ADDENDUM NO. 3

Client: City of Elwood
Municipal Building Renovation

Issue Date: November 2, 2026

SHEET NUMBER:
P101B

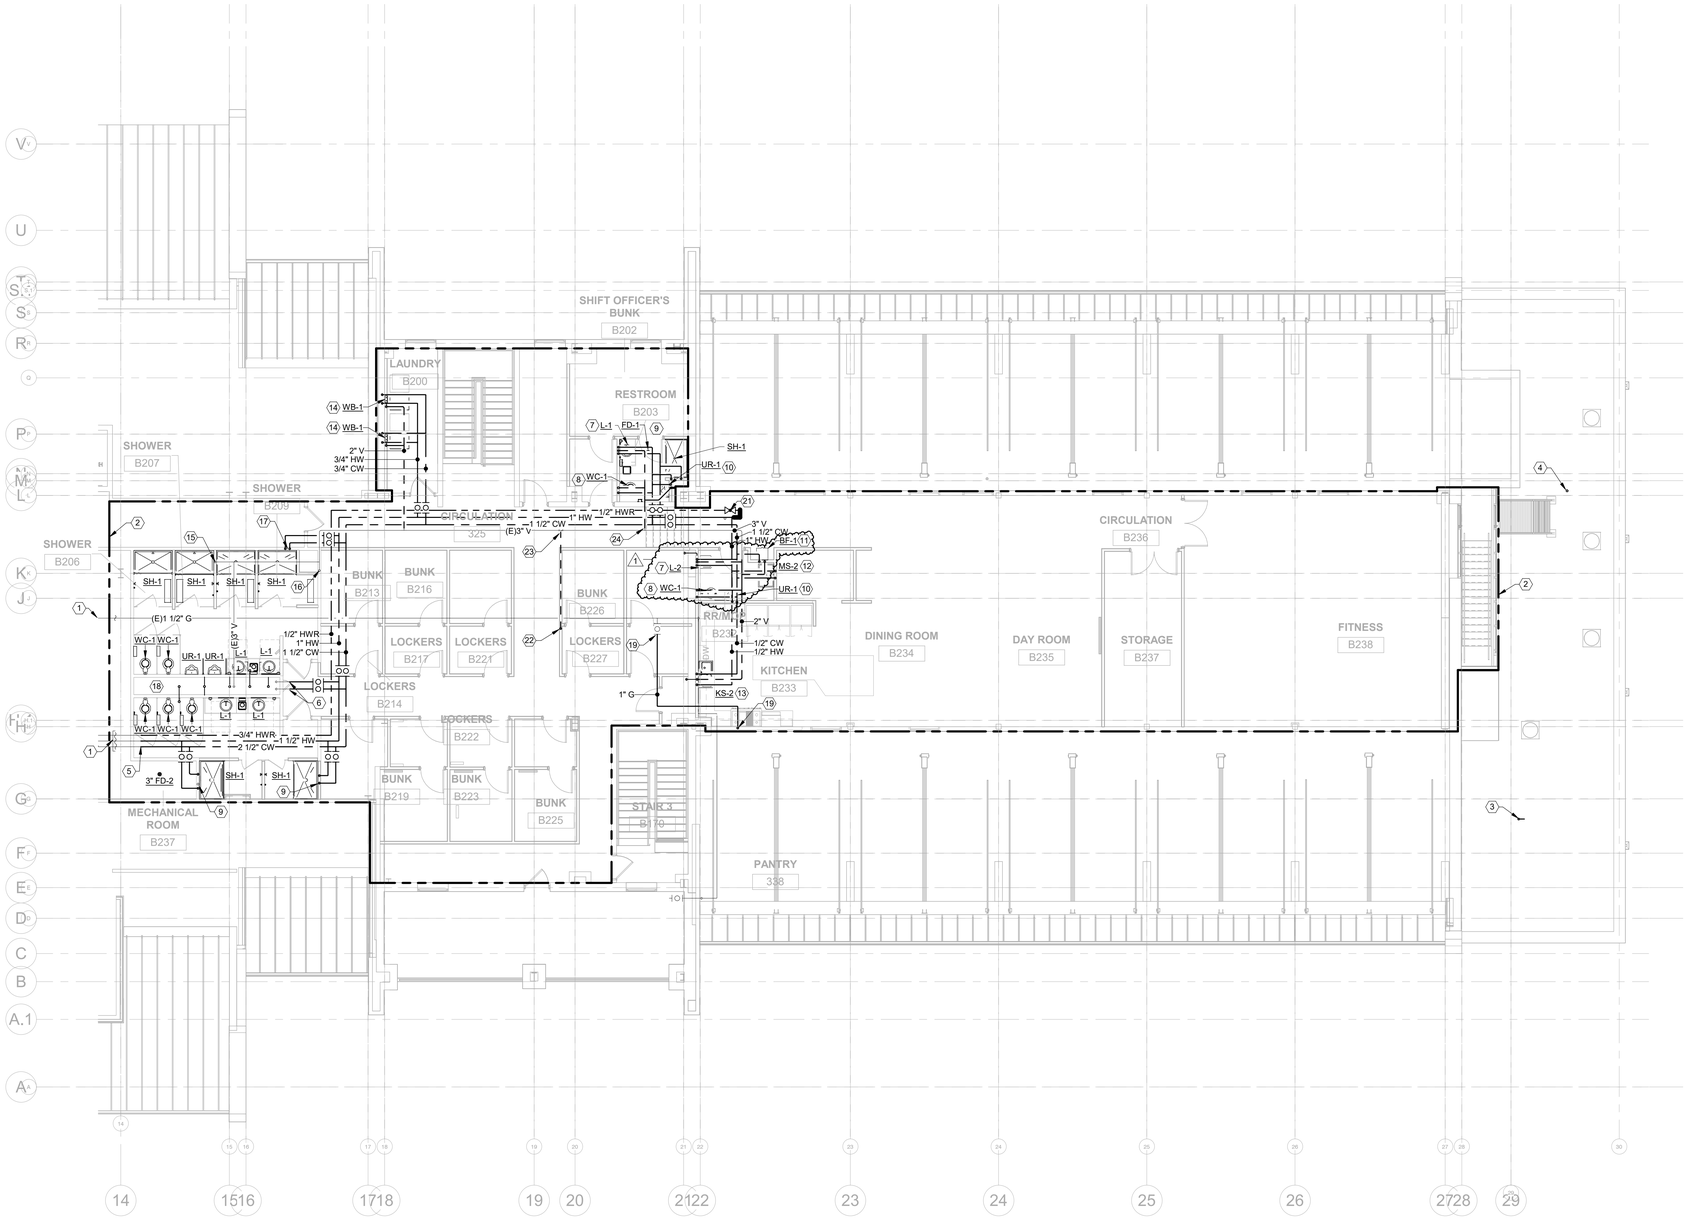
29. **Sheet No. P101B – 1ST FL Plan Plumbing – Area B**
a. Added note 40.
b. Added balancing valve tag.
c. Added sanitary piping.
d. Added sanitary riser tags.
e. Added floor drain tag.

SHEET NUMBER:
P701

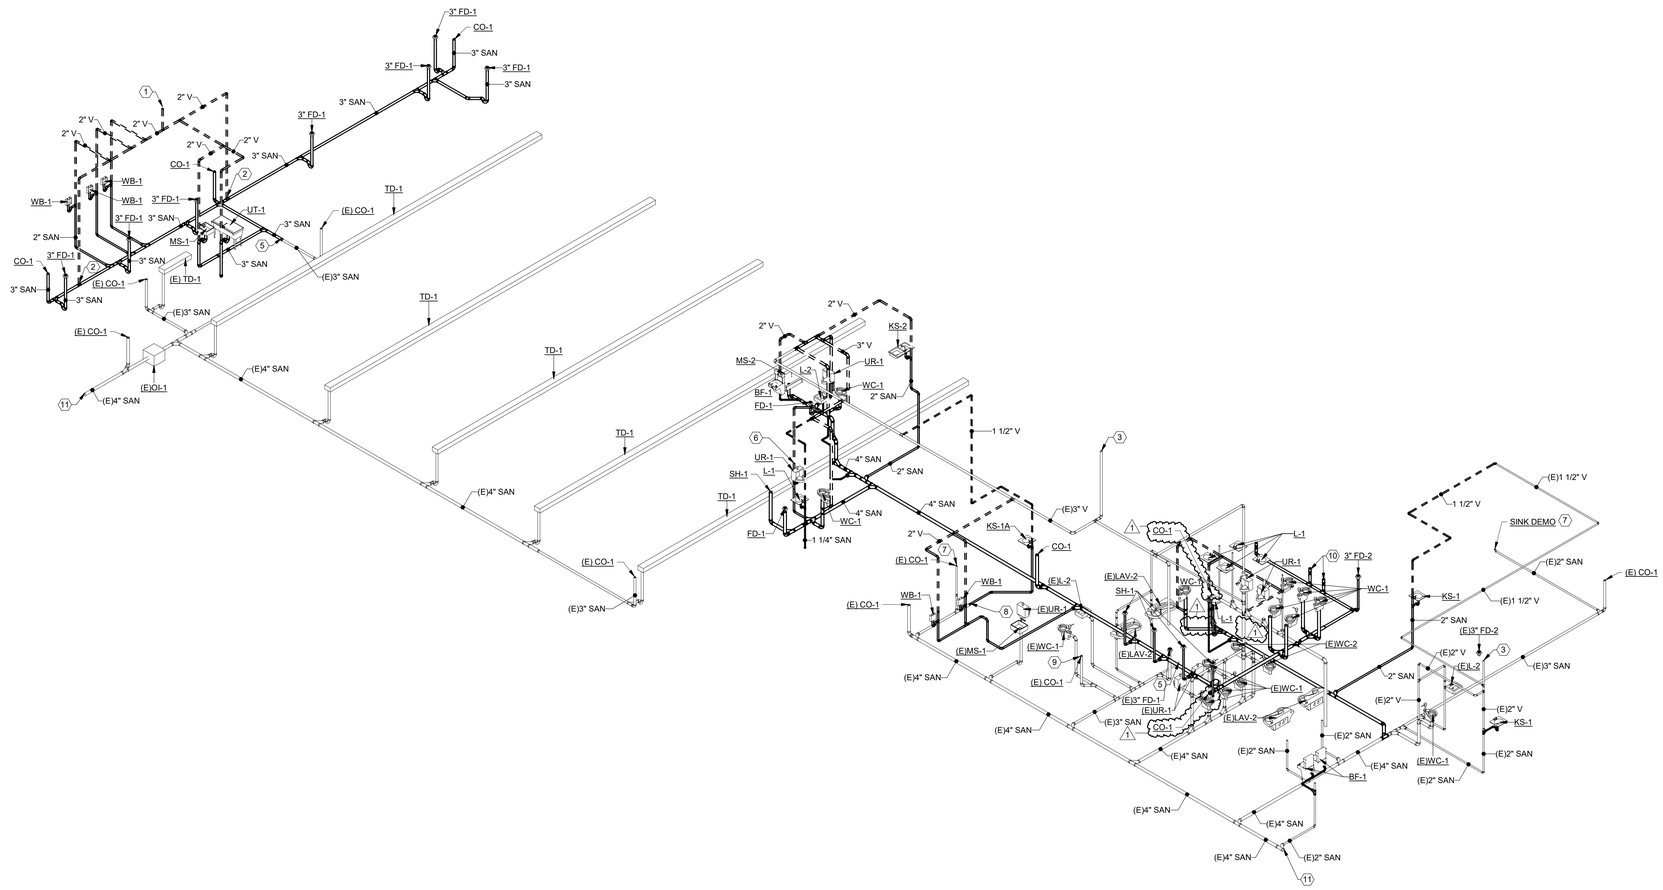
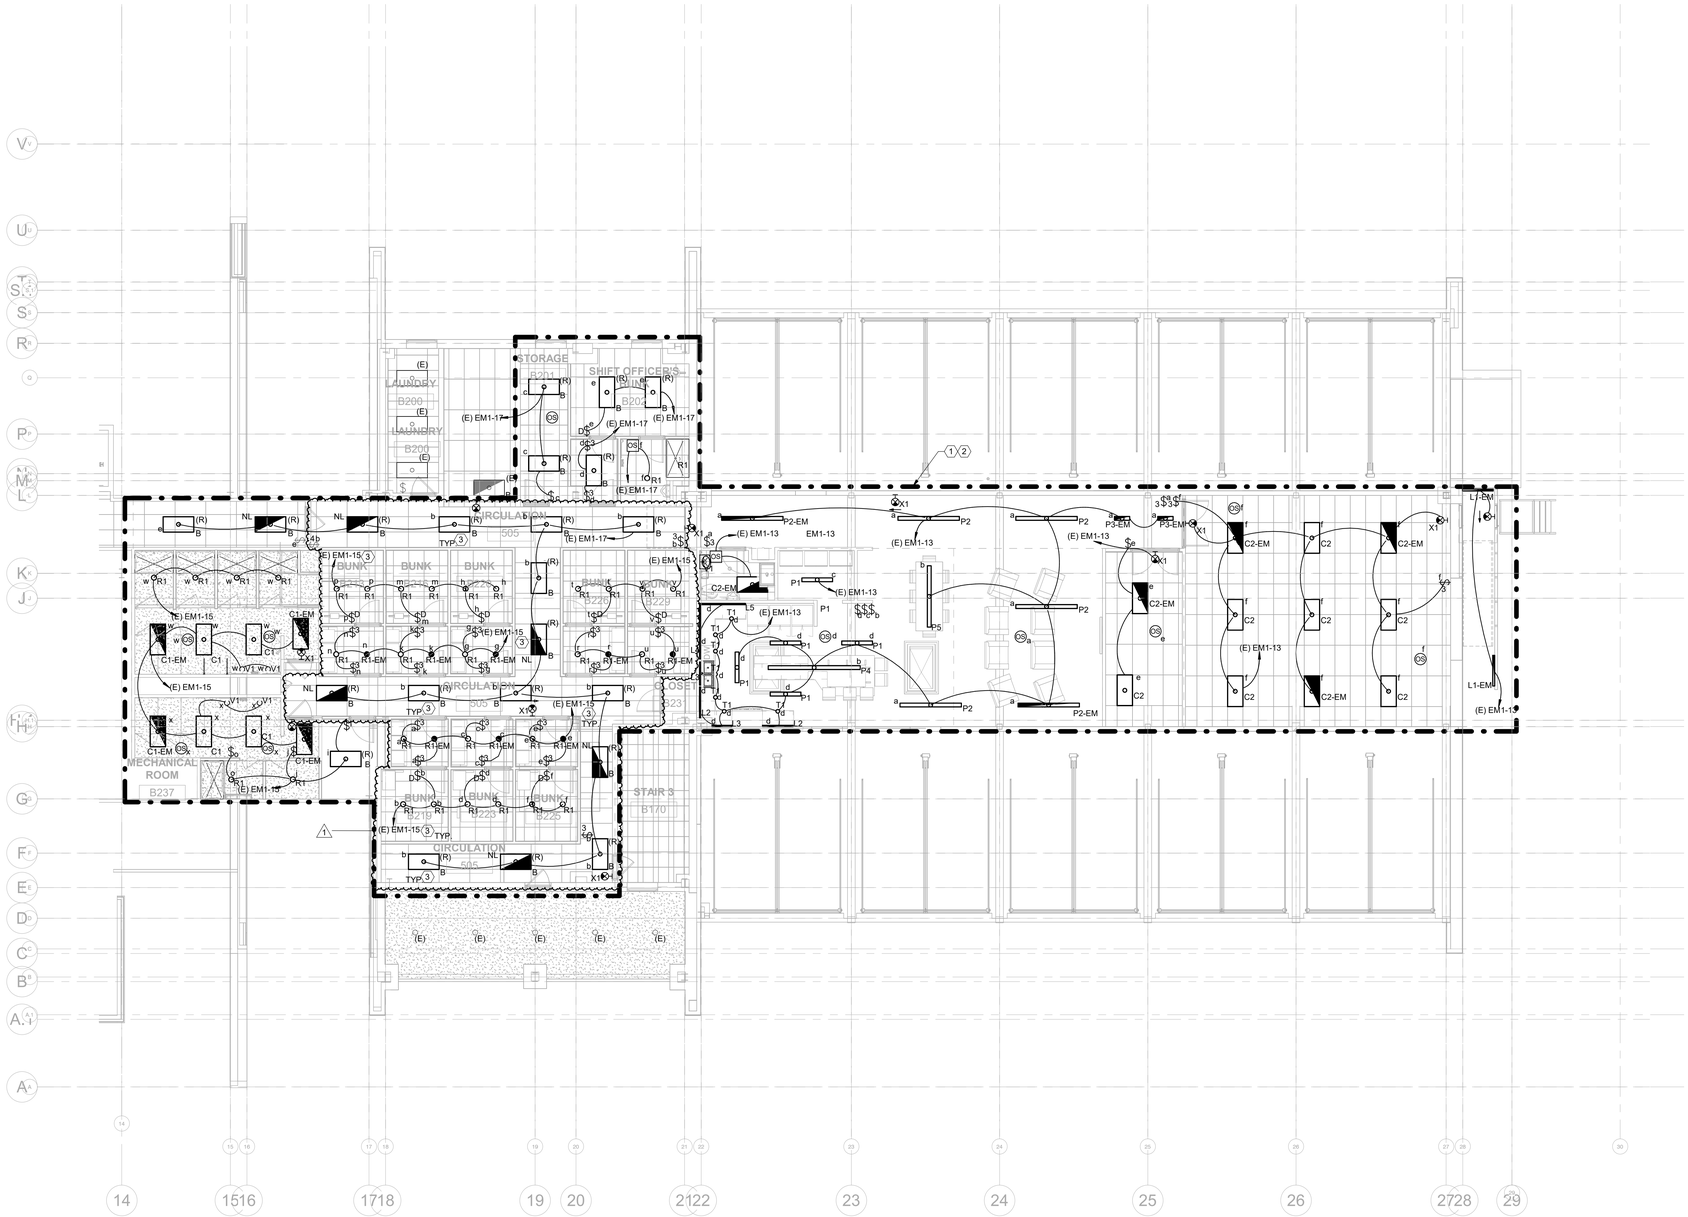
31. **Sheet No. P701 – Diagrams – Plumbing**
a. Added cleanout tags.
b. Removed pipe tags.
